FINAL GRADING AND EROSION CONTROL PLANS
FALCON MEADOWS AT BENT GRASS FILING NO. 3
FALCON, CO 80831 - EL PASO COUNTY
CHALLENGER COMMUNITIES, LLC

EPC STORMWATER REVIEW COMMENTS
IN ORANGE BOXES WITH BLACK TEXT

GALLOWAY RESPONSE TO COMMENTS
IN BLUE BOXES WITH WHITE TEXT

GRADING & EROSION
CONTROL COVER SHEET

G1.2

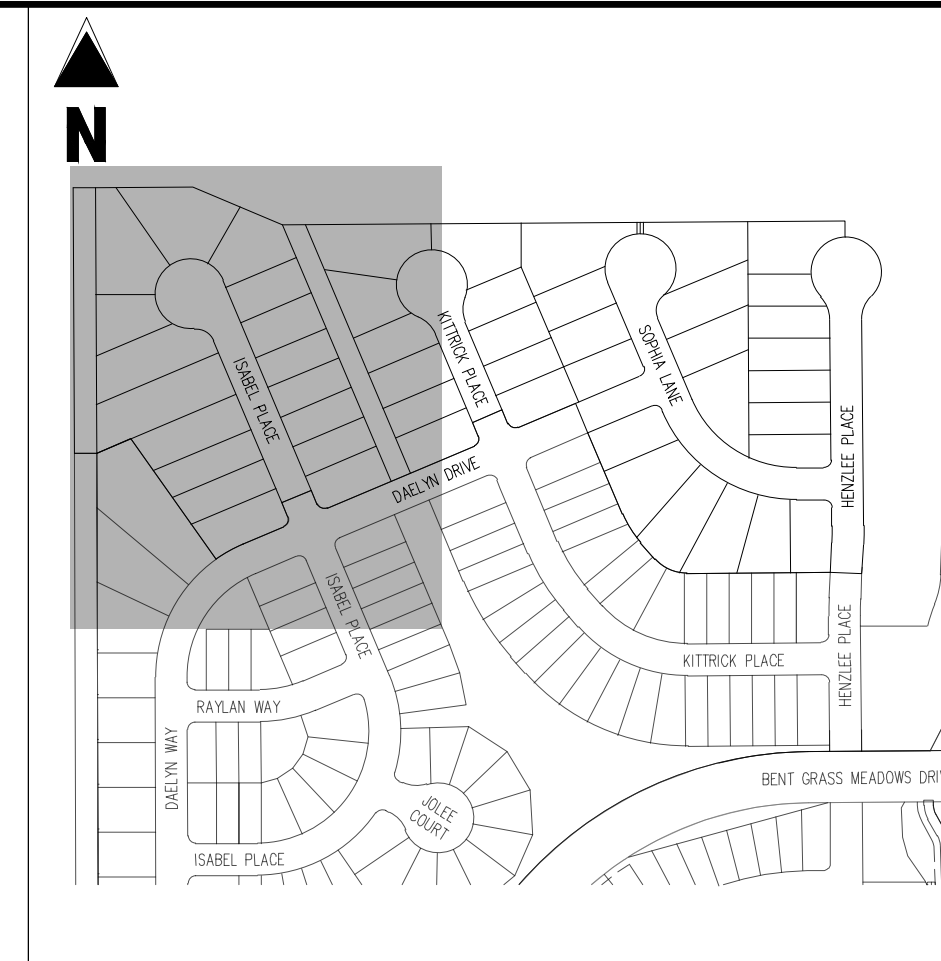
Please show the existing inlet and storm pipe so the appropriate protection can be shown

show existing storm drains and inlets so IP can appropriately be shown.

EX. STORM AND INLET PROTECTION ARE VISIBLE

EX. STORM AND INLET
PROTECTION ARE VISIBLE

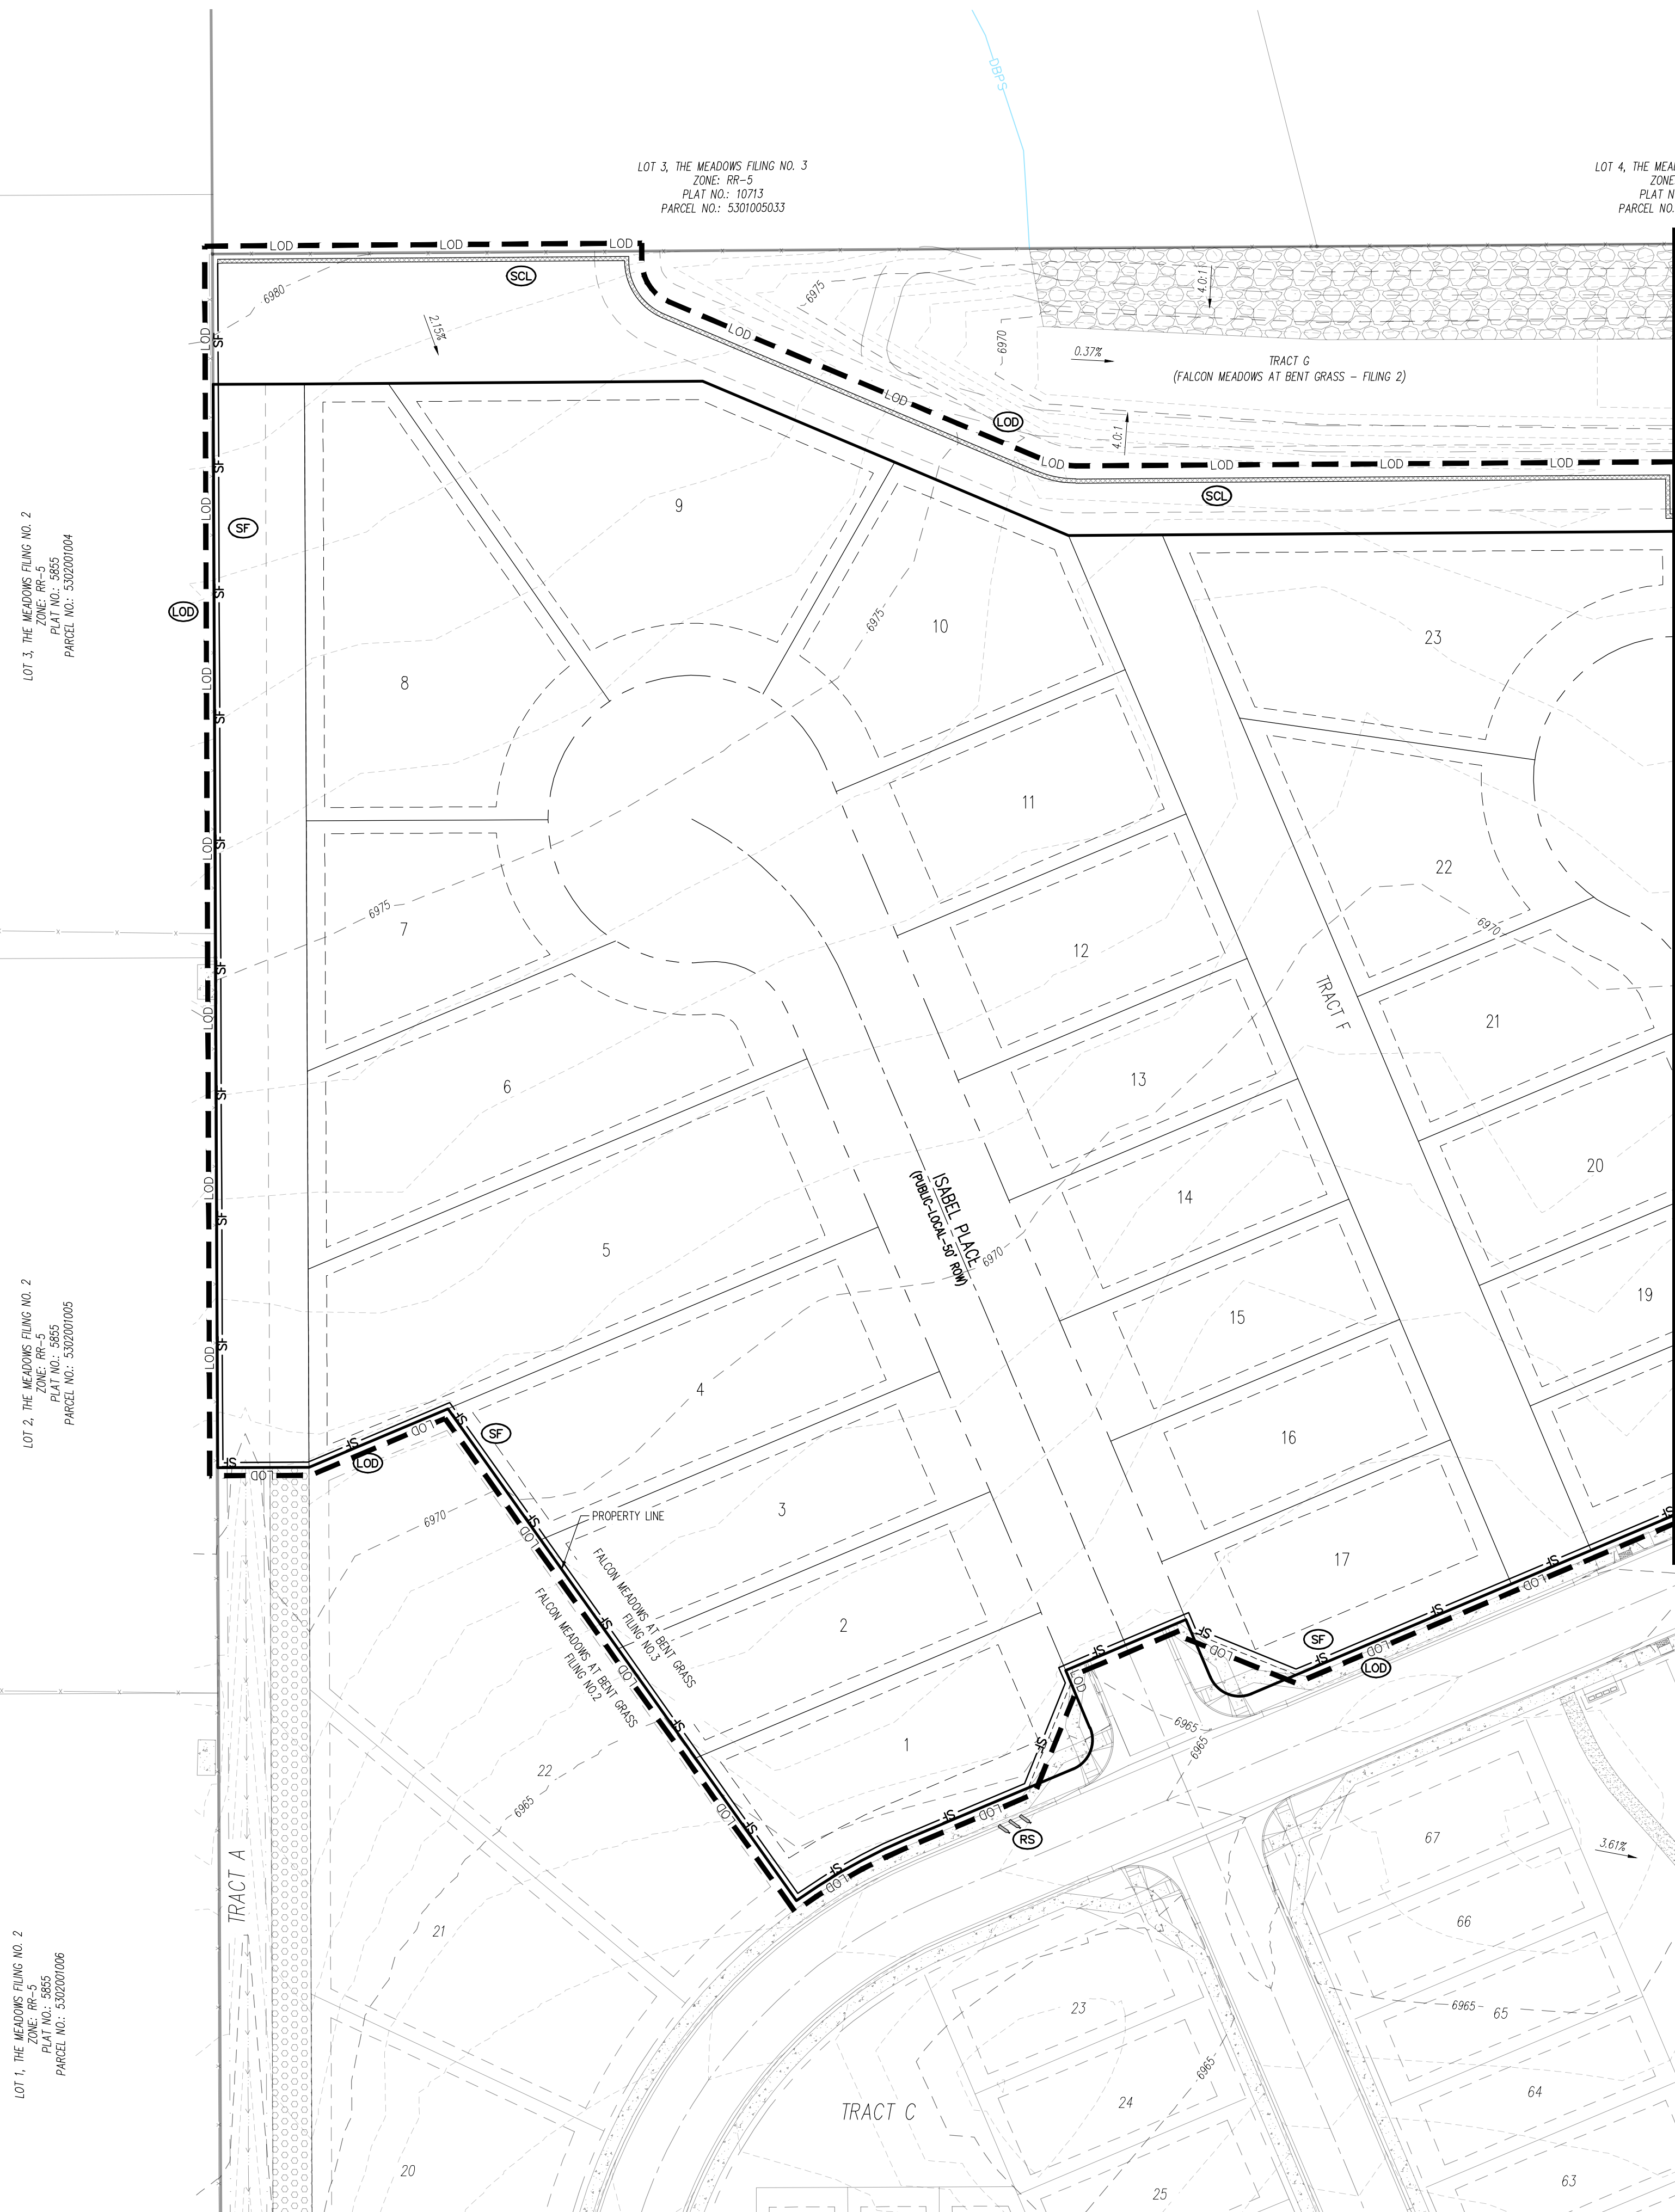
This is to occur under another filing, correct? Revise to reflect BMPs for this filing.

show existing storm drains and inlets so I can appropriately be shown.

REVISÉ AS REQUESTED

EX. STORM AND INLET PROTECTION ARE VISIBLE IN APPLICABLE SHEETS (N/A IN G1.2)

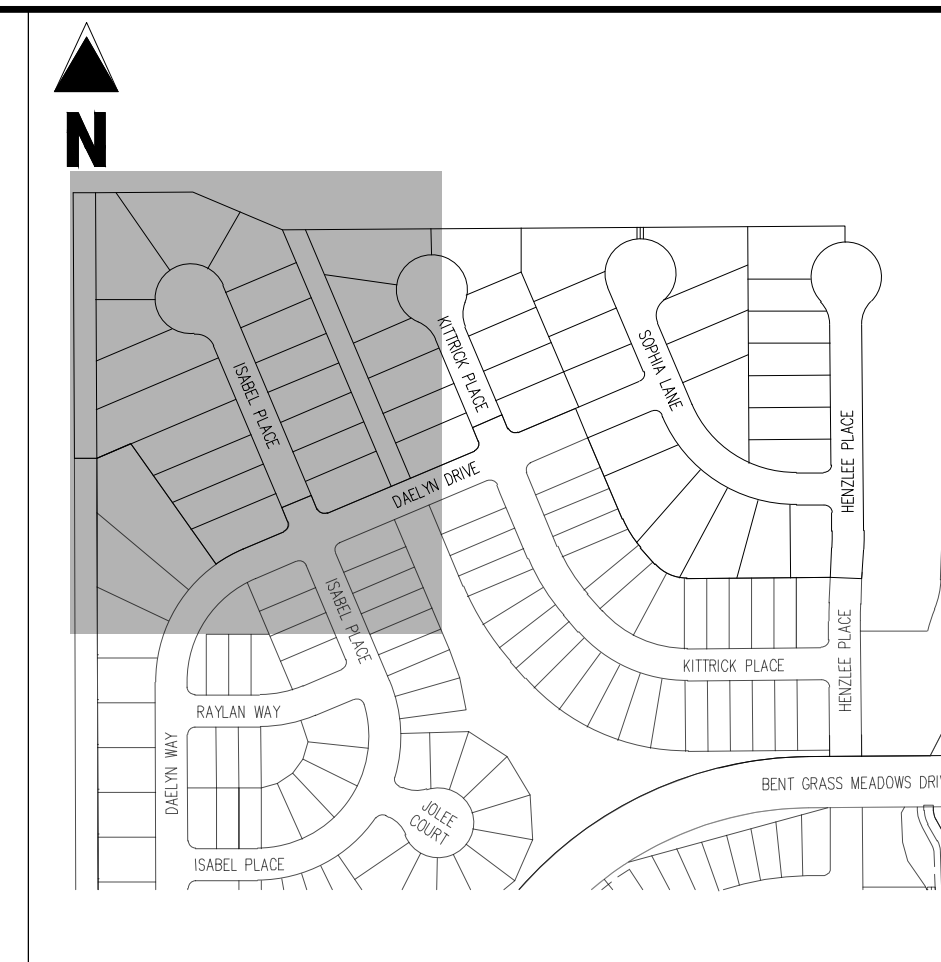
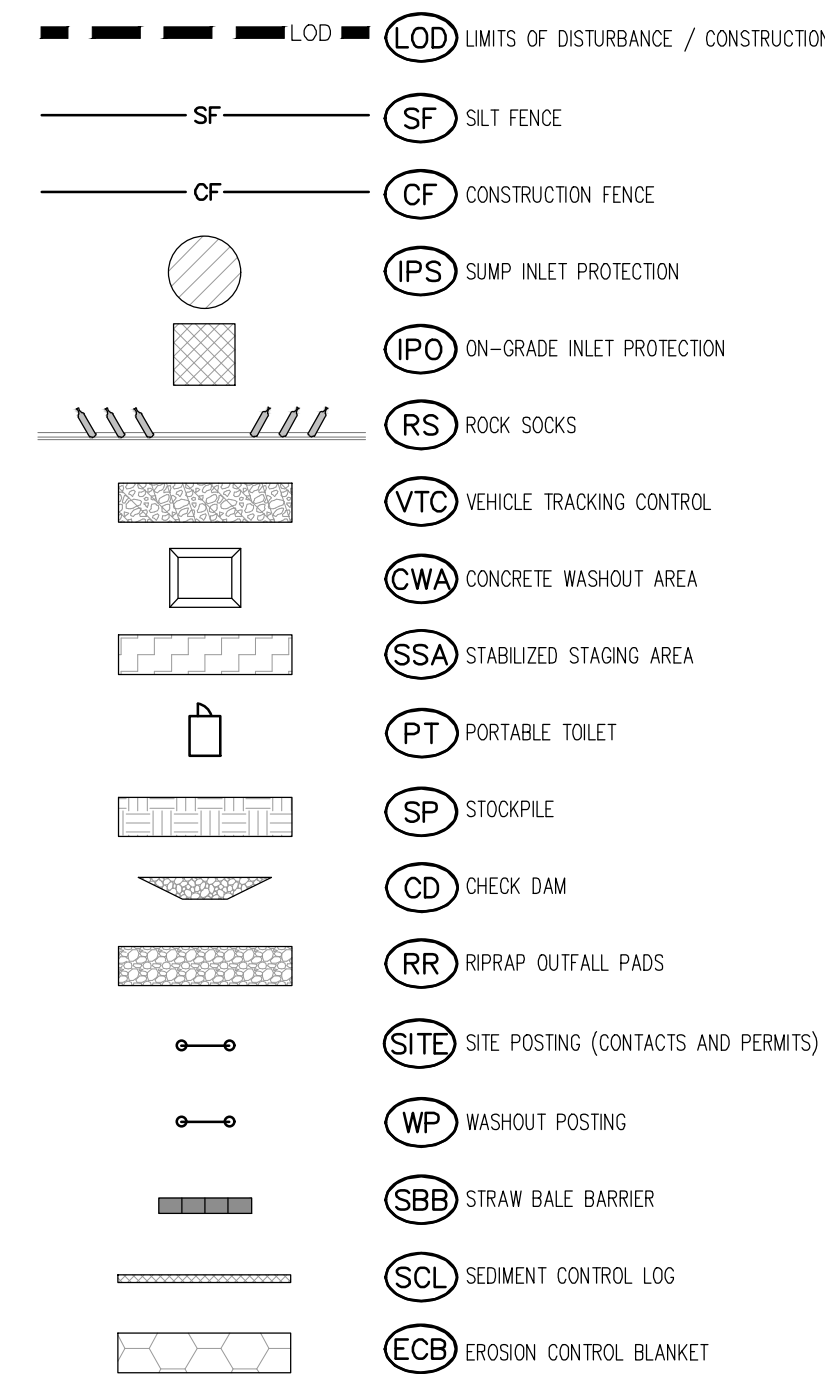
show existing storm drains and inlets so IP can appropriately be shown.

EX. STORM AND INLET PROTECTION ARE VISIBLE

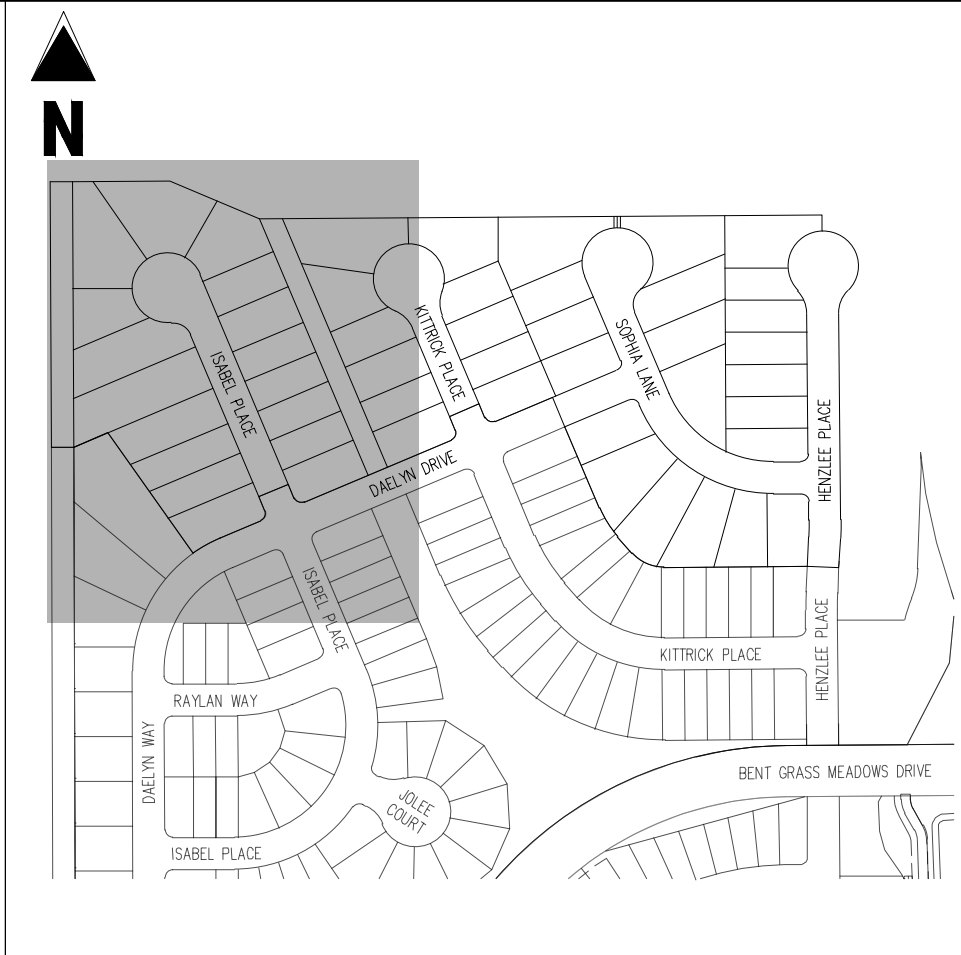
Alot of the runoff from the proposed development on this sheet (about 2-3 acres) is tributary to this point. Per pg 24 of the SWMP text, all flows from F3 will be conveyed to the existing North and South ponds.

This is a typical comment for the previous sheet as well (except the areas are different sizes and are trib to the North Pond).
